Appendix I of RNTPC
Paper No. A/YL-KTN/1042B

**APPLICATION FOR PERMISSION
UNDER SECTION 16 OF
THE TOWN PLANNING ORDINANCE
(CAP. 131)**

(a) Proposed use(s)/development 擬議用途/發展	Proposed Temporary Animal Boarding Establishment (Dog Kennel) for a Period of 3 Years and Filling of Land (Please illustrate the details of the proposal on a layout plan) (請用平面圖說明擬議詳情)

This letter intends to supersede our letter dated 9.9.2024. Our response to the comments of the CE/MN, DSD is as follows:

Figure 4. Intensity – Duration – Frequency Curves
(for durations not exceeding 4 hours)

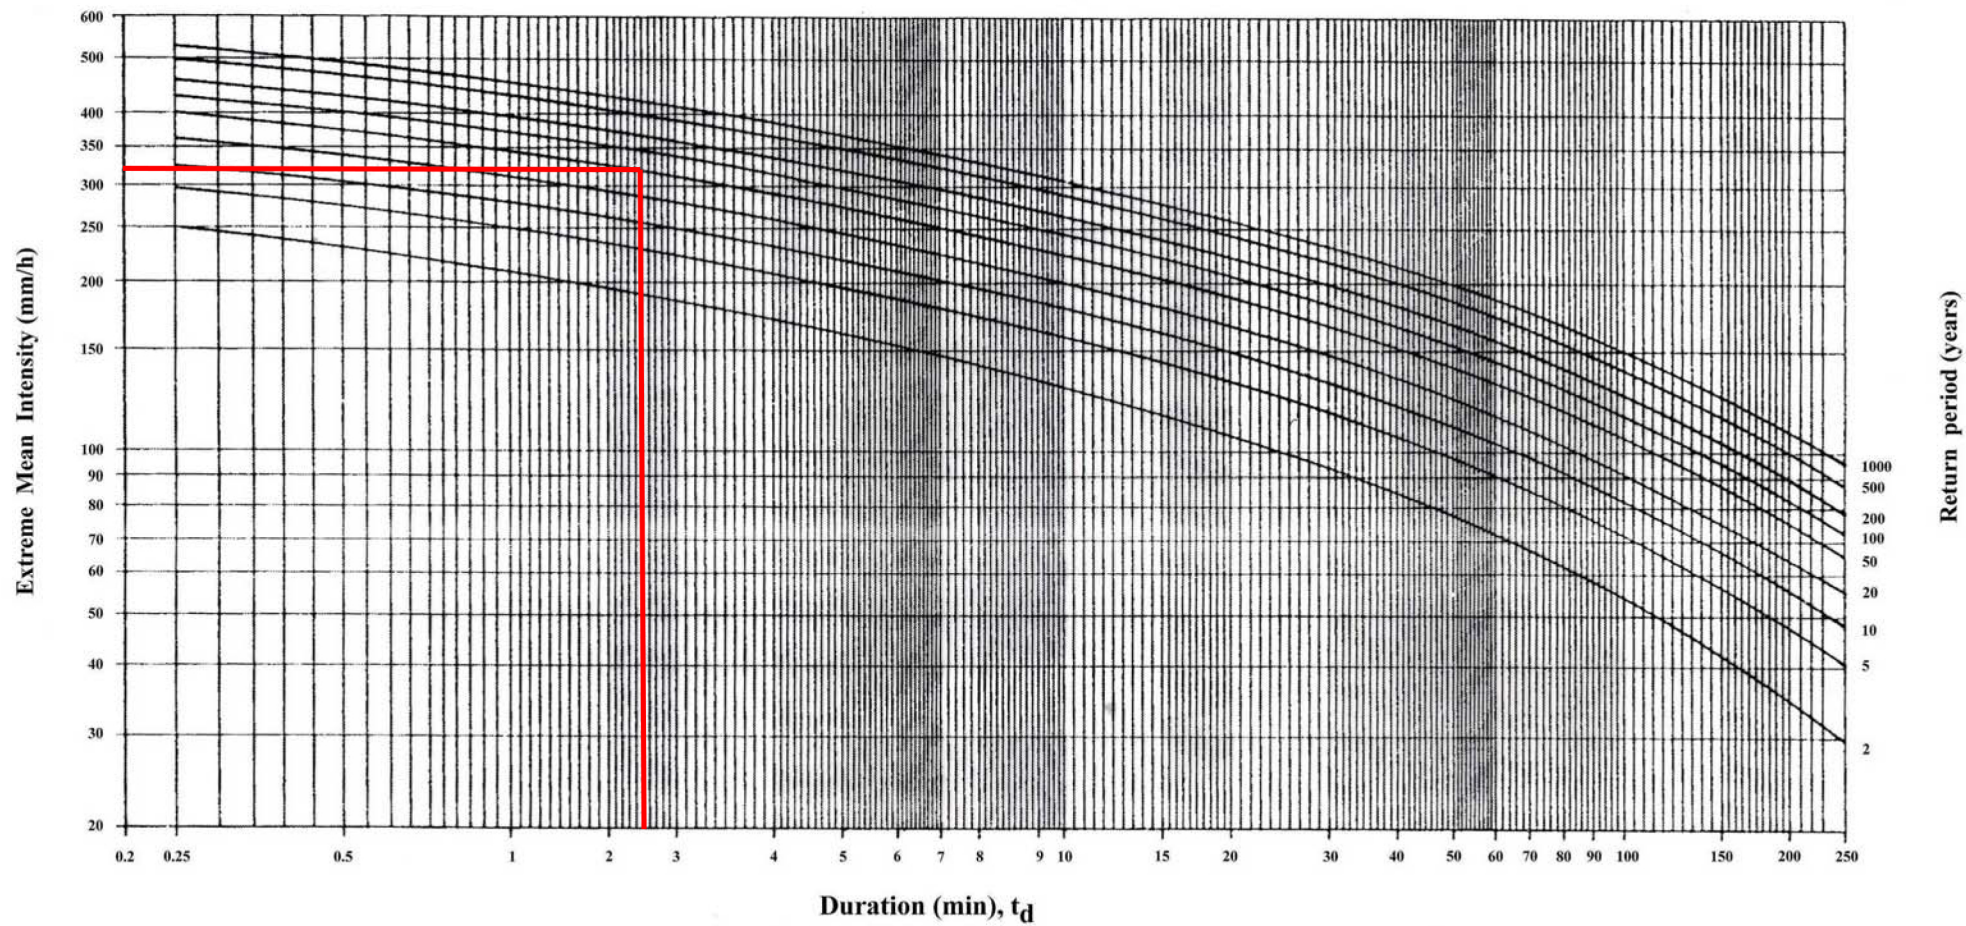
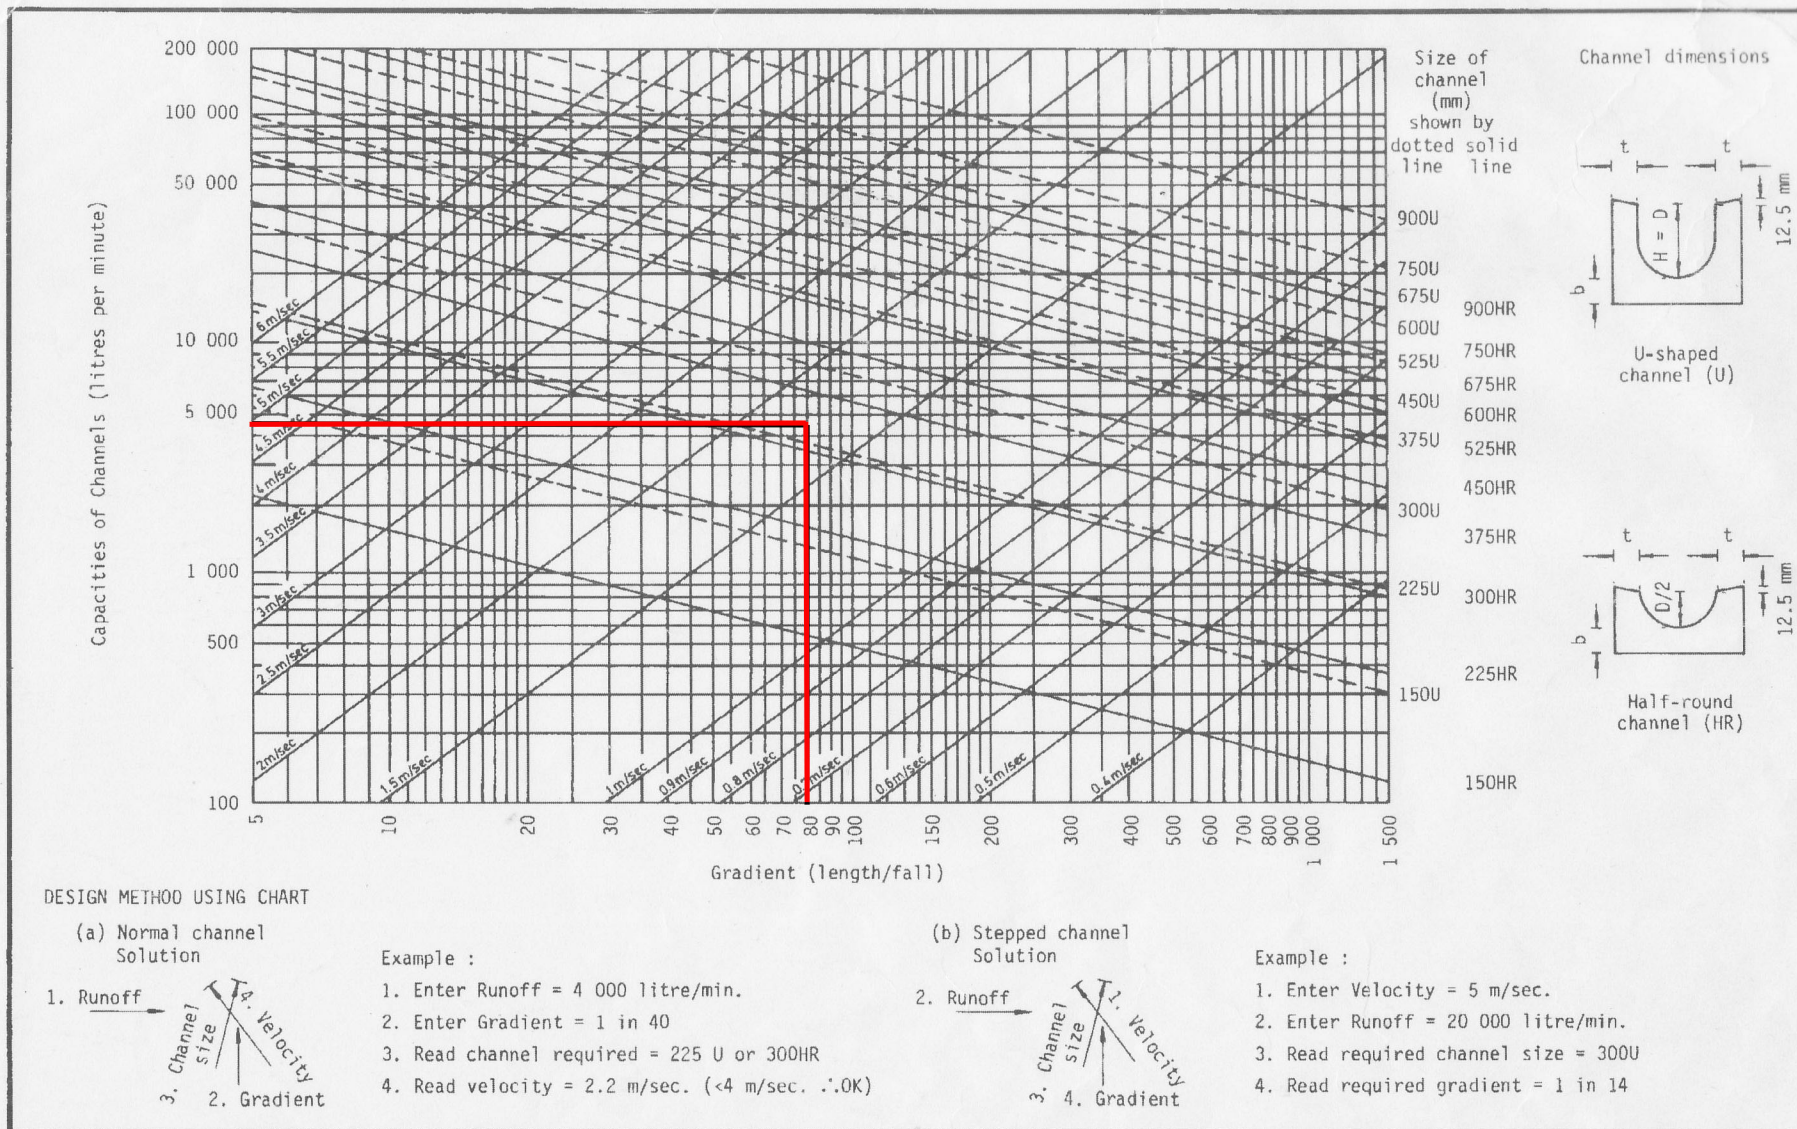
CE/MN, DSD's comments	Applicant's response
(a) Section 1.2: Please provide relevant IDF curves and chart of the rapid design of channels with your designed values indicated on curves/ chart for reference.	Noted. Please see attached.

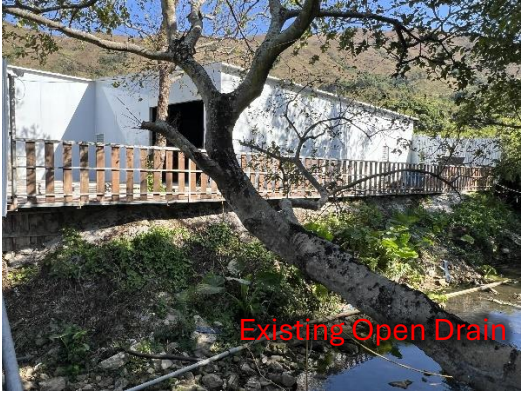
CE/MN, DSD's comments	Applicant's response
<p>6. Previous comment (f) has not been addressed. Please provide site photos to show existing condition and existence of the existing drainage facilities which receive the discharge from the application site.</p> <p>(f) The applicant should check and ensure the hydraulic capacity of the existing drainage facilities would not be adversely affected by the captioned development. Please provide site photos to show existing condition of the existing drainage facilities which receives the discharge from the application site.</p>	<p>Noted. The existing drainage facilities is the only drainage facilities adjacent to the application site for dissipation. The discharge from the application site is minimal because the land filling at the application site is minimal. The additional discharge would not affect the existing drainage facilities.</p> <p>Please refer to photo below.</p>

Figure 4a – Intensity-Duration-Frequency Curves of HKO Headquarters
(for durations not exceeding 4 hours)

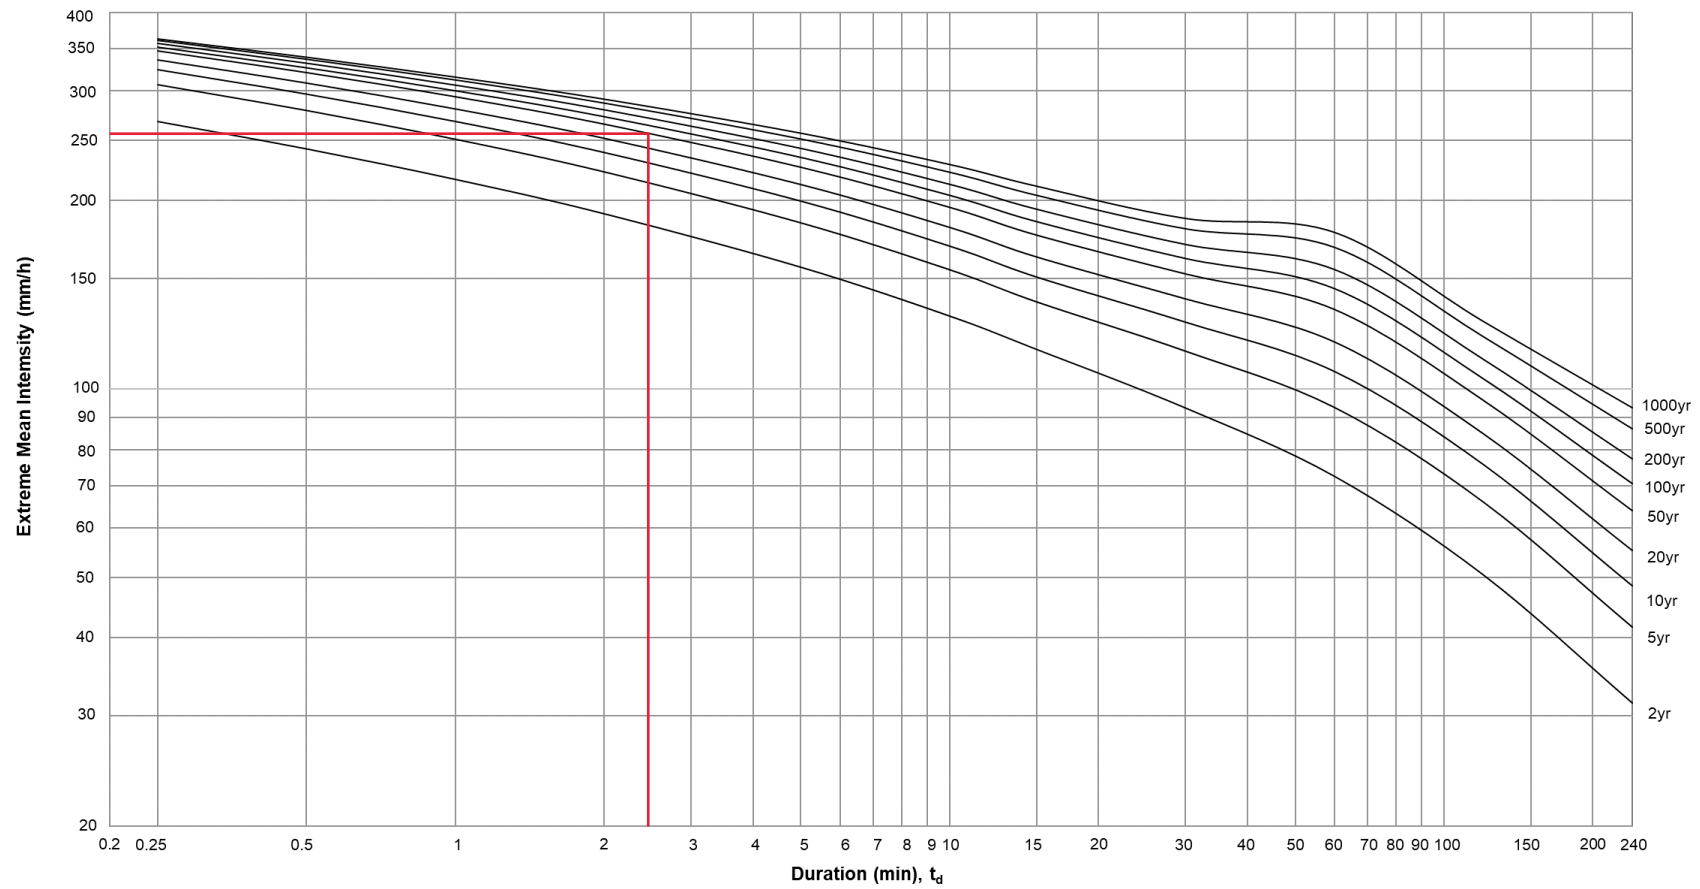
CE/MN, DSD's comments	Applicant's response
1. SDM corrigendum no. 1/2022 and 1/2024 should be considered.	Noted. <i>Intensity-Duration-Frequency Curves</i> has been updated.
2. GEO Technical Guidance Note No. 43 should be adopted for u-channel checking as Figure 8.7 of the Geotechnical Manual for Slopes (GCO, 1984) was superseded.	Noted. <i>Chart for the Rapid Design of Channels</i> has been updated.
3. Previous comment (d) has not been fully addressed. All proposed drainage facilities should be shown in cross sections. (d) All proposed drainage facilities and walls/ hoarding should be shown in cross sections.	Noted, please refer to updated cross section.
4. Cross sections – Please also indicate the connection profile between proposed land filling and existing ground level.	Noted, please refer to updated cross section.

Figure 5

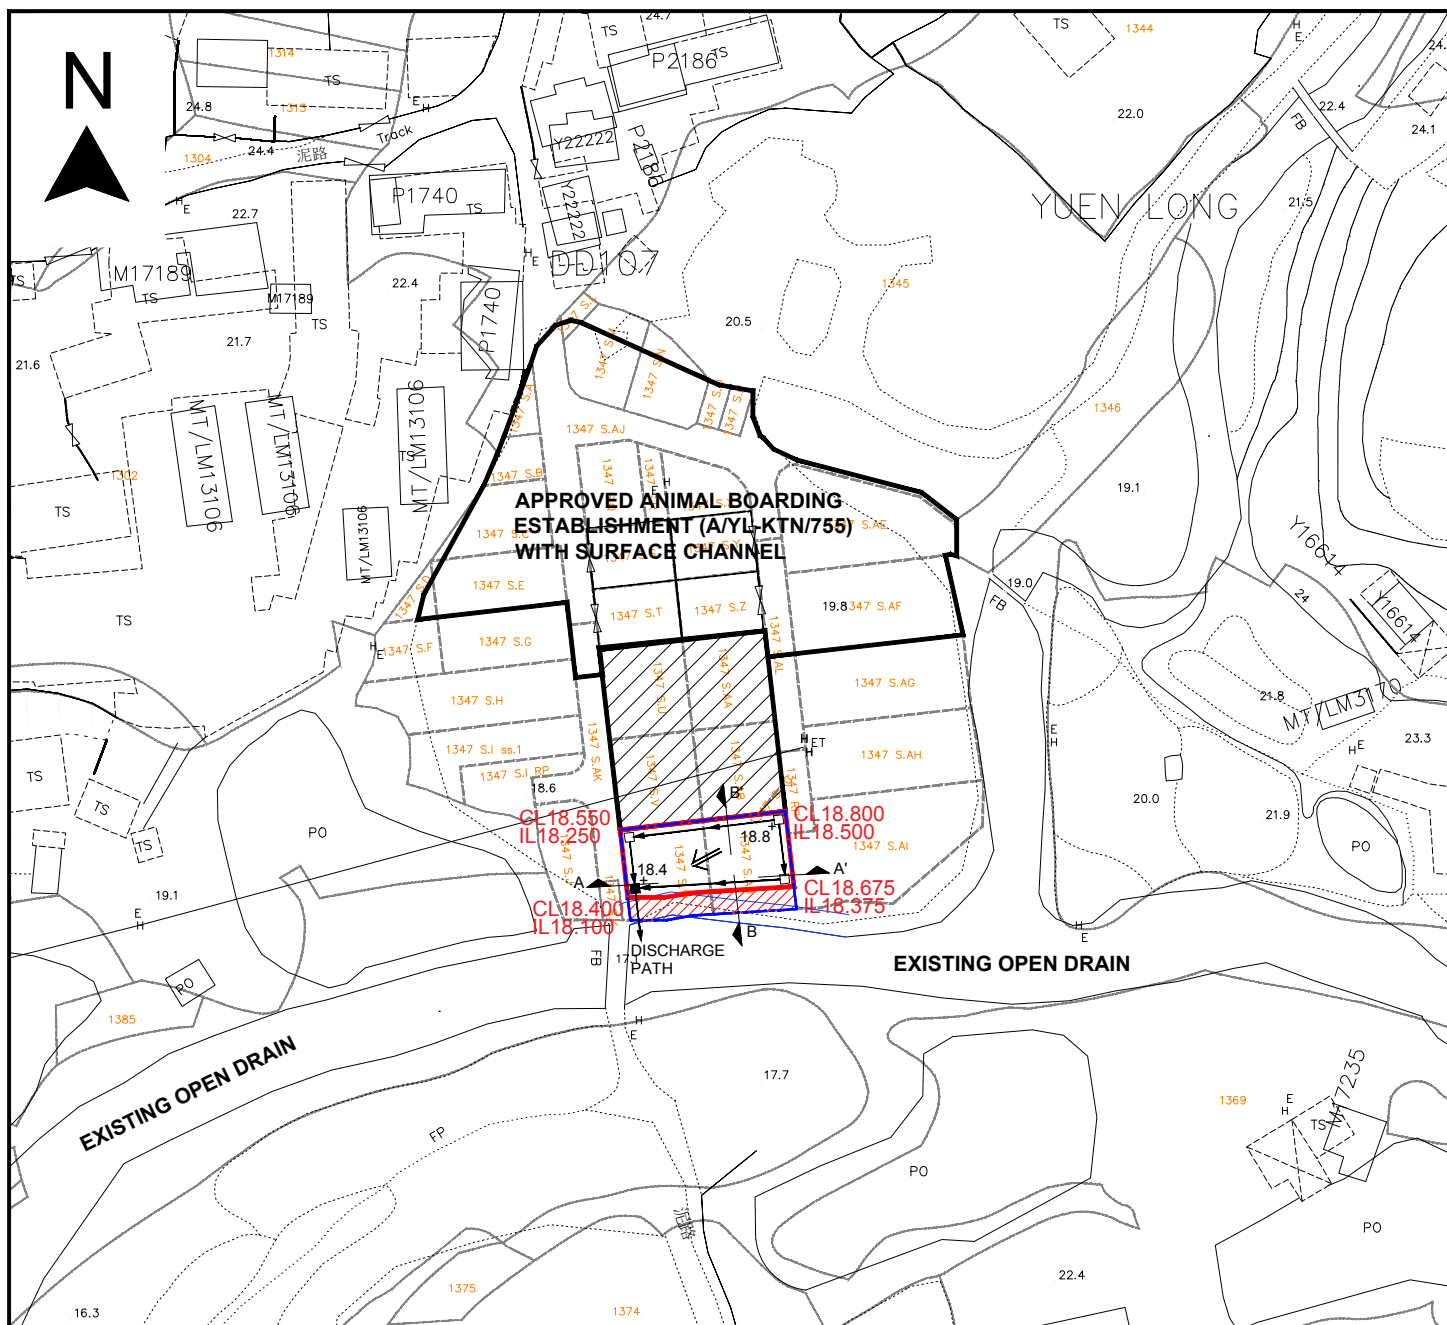
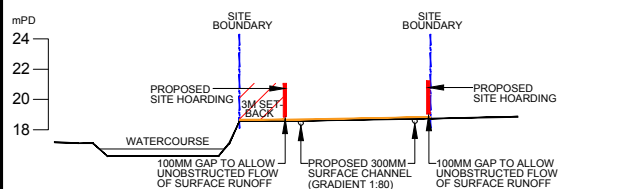
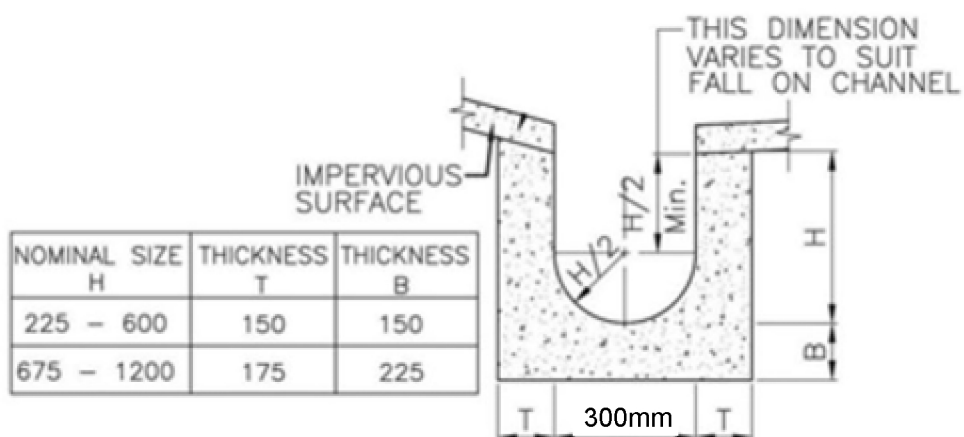
(b) For Section B-B shown in the drainage plan, please provide a cross section showing the existing watercourse as well as the boundary of the proposed development.	Noted. Please see updated drainage plan.

(c) Please provide a cross-section demonstrating how the proposed development would not affect the existing watercourse/natural stream.	Noted. Please see updated drainage plan. Site hoarding will be provided to separate the site from the watercourse.

(d) All proposed drainage facilities and walls/ hoarding should be shown in cross sections.	Noted. Please see updated drainage plan.
(e) The existing drainage facilities, to which the stormwater of the development from the subject site would discharge, are not maintained by this office. The applicant should identify the owner of the existing drainage facilities to which the proposed connection will be made. The applicant shall demonstrate that the proposed drainage construction / improvement / modification works and the operation of the drainage can be practicably implemented.	Noted. The existing drainage facilities, to which the stormwater of the development from the subject site would discharge, are not maintained by CE/MN, DSD. The applicant would identify the owner of the existing drainage facilities to which the proposed connection will be made. The applicant shall demonstrate that the proposed drainage construction / improvement / modification works and the operation of the drainage can be practicably implemented.

Figure 4

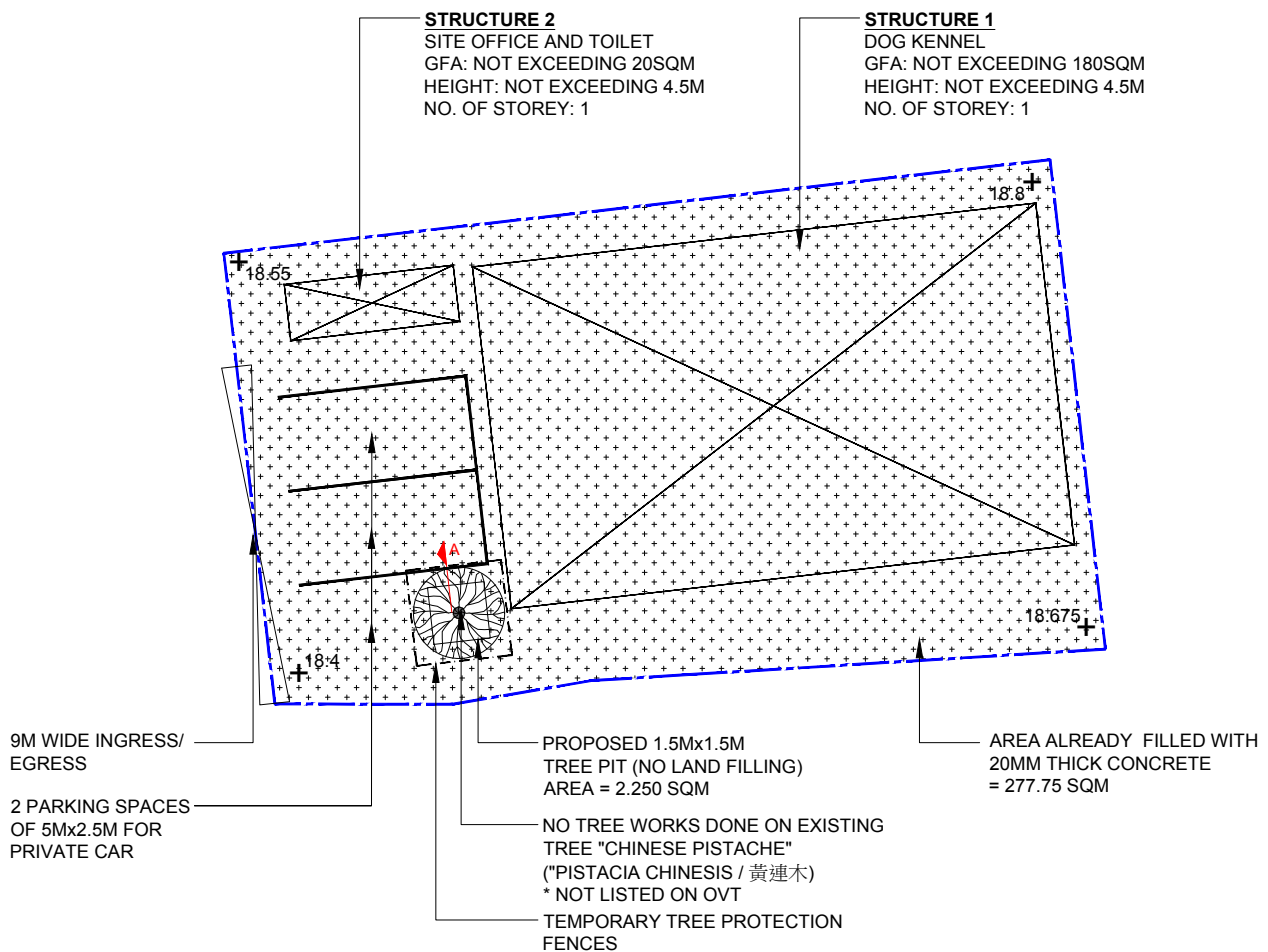
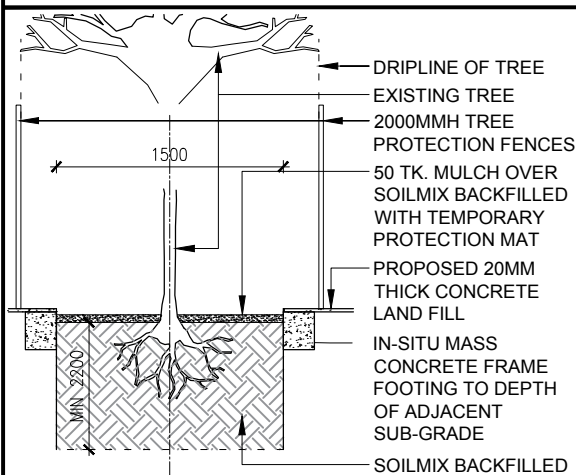
- Figure 4 (Landfill Plan) - added paved/unpaved area, tree information and measures, note "No further filling required"; change 3 car parking spaces to 2.
- Figure 6 (FSI Plan) - layout updated to tally with other revised drawings. Revised scale of drawings.
- Figure 7 (Internal Layout Plan) - layout updated to tally with other revised drawings. Revised scale of drawings. Added detail layout of dog kennel enclosures
- Form S16-III - Page 5 & 11 involving no. of car parking spaces and page 6 involving area of filling of land
